# Schematic Development Plan SDP-9003-2021 14 Firstfield Road

Applicant: 14 Firstfield Holdings, LLC

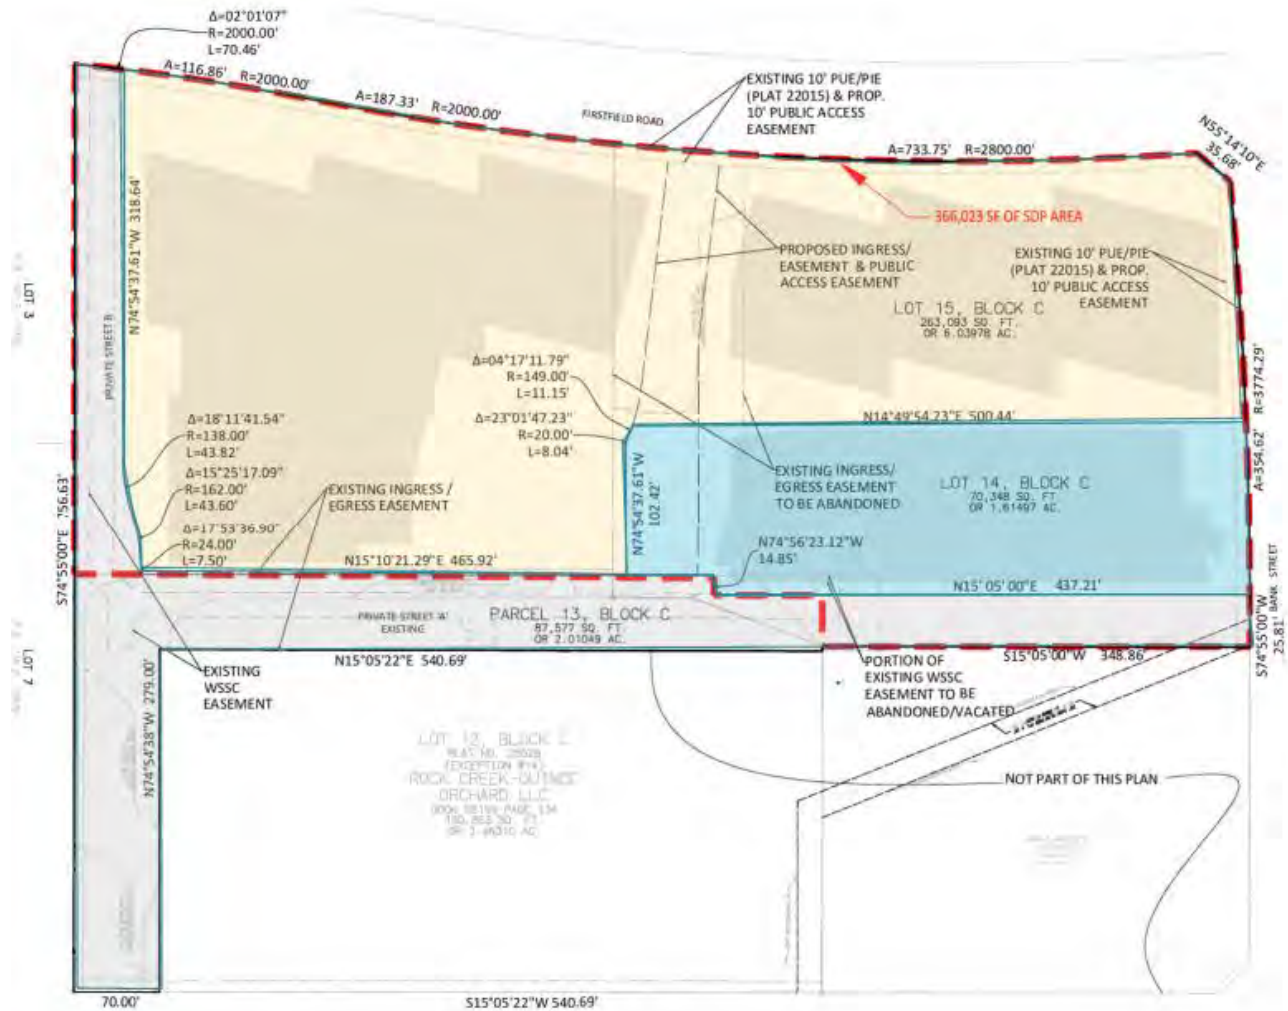
As part of the proposed project, the Applicant seeks a parking waiver to set the parking ratio for the development in the MXD Zone. Pursuant to § 24-160D.8(a) of the City Code, the council has the authority to determine the appropriate number of spaces at schematic development plan review and the planning commission will determine the final number at final site plan review. The requested parking ratio of 1 space per 650 square feet is different than the 1 space per 428 square foot ratio approved for 700 Quince Orchard Road under amendment to schematic development plan application ASDP-8610-2020. As stated in the applicant's Statement of Justification (Exhibit #), the different parking ratio is requested because the 14 Firstfield Property has a higher percentage of integrated light manufacturing and less office area than the 700 quince Orchard property; therefore, parking demand is lower at 14 Firstfield Property since the integrated light manufacturing uses have an overlap in personnel and in some cases duplicative work spaces with the same personnel. In addition, Novavax projects that one-third of the workforce will stay remote, one-third will work on hybrid
